NL-15-0699

Joseph M. Farley Nuclear Plant Unit 1  
Completion of Required Action by NRC Order EA-12-051  
Reliable Spent Fuel Pool Level Instrumentation

NRC Requests for Information

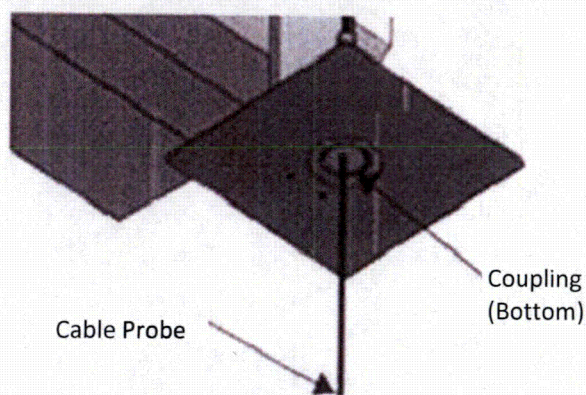
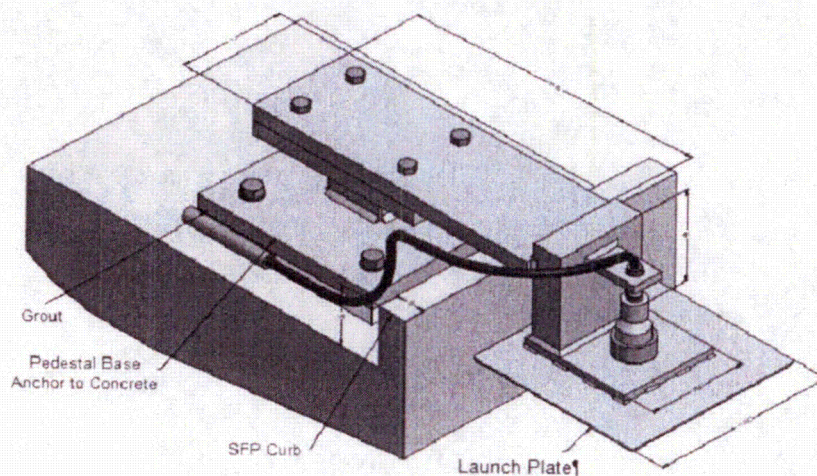
- b) A description of the manner in which the level sensor (and stilling well, if appropriate) will be attached to the refueling floor and/or other support structures for each planned point of attachment of the probe assembly. Indicate in a schematic the portions of the level sensor that will serve as points of attachment for mechanical/mounting or electrical connections.

- b) The mounting bracket is attached to the SFP concrete floor utilizing expansion-type concrete anchor bolts. The level sensor consists of a stranded stainless steel cable level probe that is threaded on the top end. The probe attaches (threads) into a coupling that is secured to the mounting bracket launch plate and extends down into the pool. The attachment to the signal cable is via a coaxial connection on the top side of the launch plate coupling.

The simplified drawing below shows a representation of the attachment of the probe and the sensor cable to the mounting bracket (launch plate), and mounting bracket attachment to the SFP structure. The Farley SFP does not have a raised concrete curb and as such, the mounting bracket does not utilize the curb for support.

Figure 1

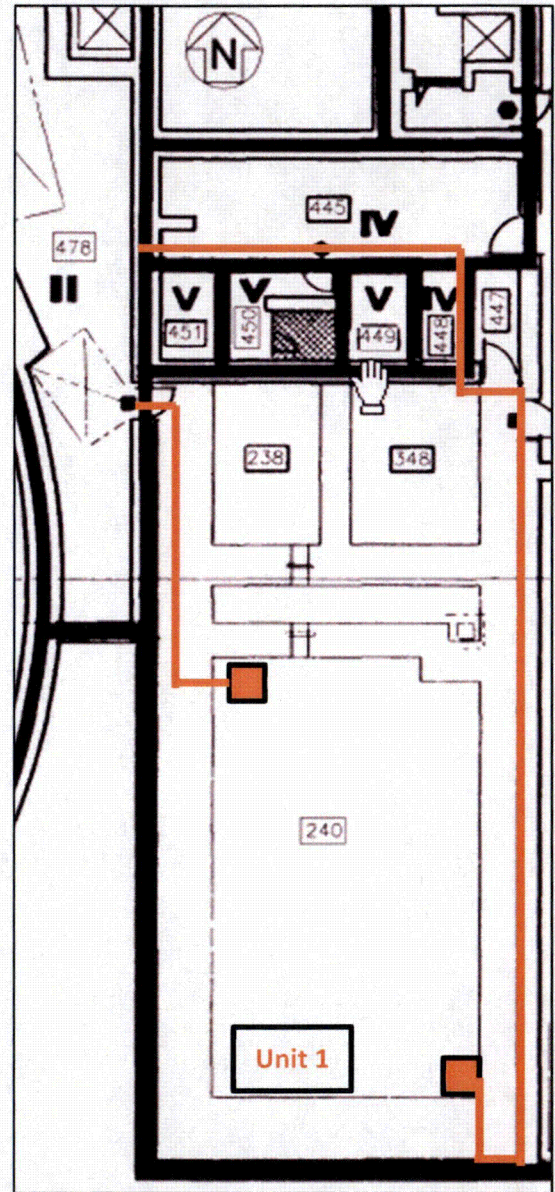
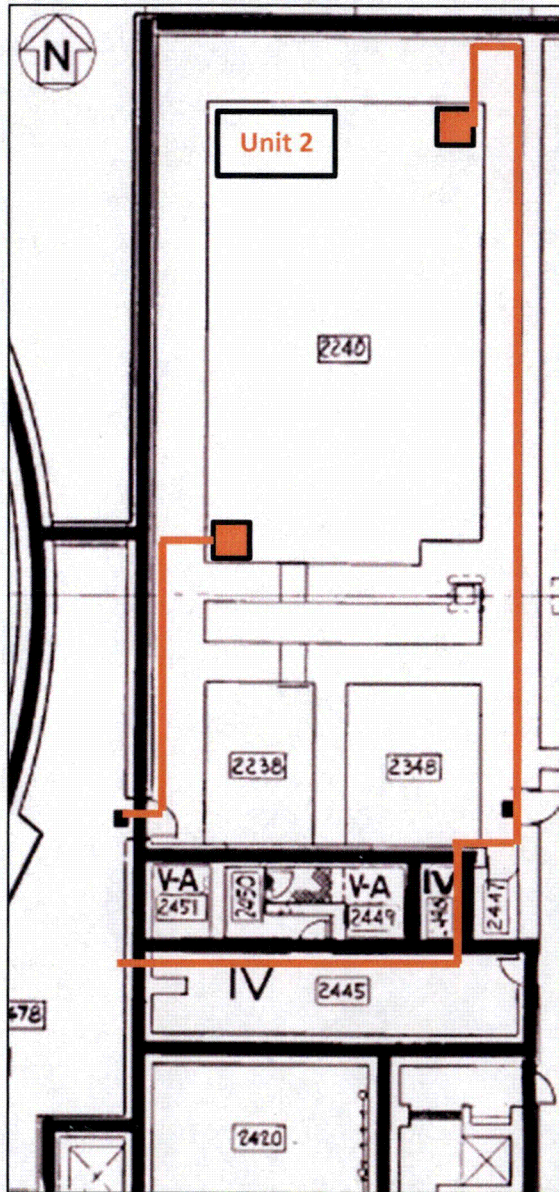
Please provide a clearly labeled sketch or marked-up plant drawing of the plan view of the SFP area, depicting the SFP inside dimensions, the planned locations/placement of the primary and back-up SFP level sensor, and the proposed routing of the cables that will extend from these sensors toward the location of the read-out/display device.

A plan view sketch of the SFP area is provided as Figure 1. The sketch depicts the SFP inside dimensions, locations/placement of the primary and alternate level sensors, and the routing of cables that extend toward the location of the electronics. Physical separation of the primary and alternate channels, to the extent practicable and comparable to the short side of the pool, is used to provide reasonable protection of the level indication function against missiles that may result from the damage to the structure over the SFP.
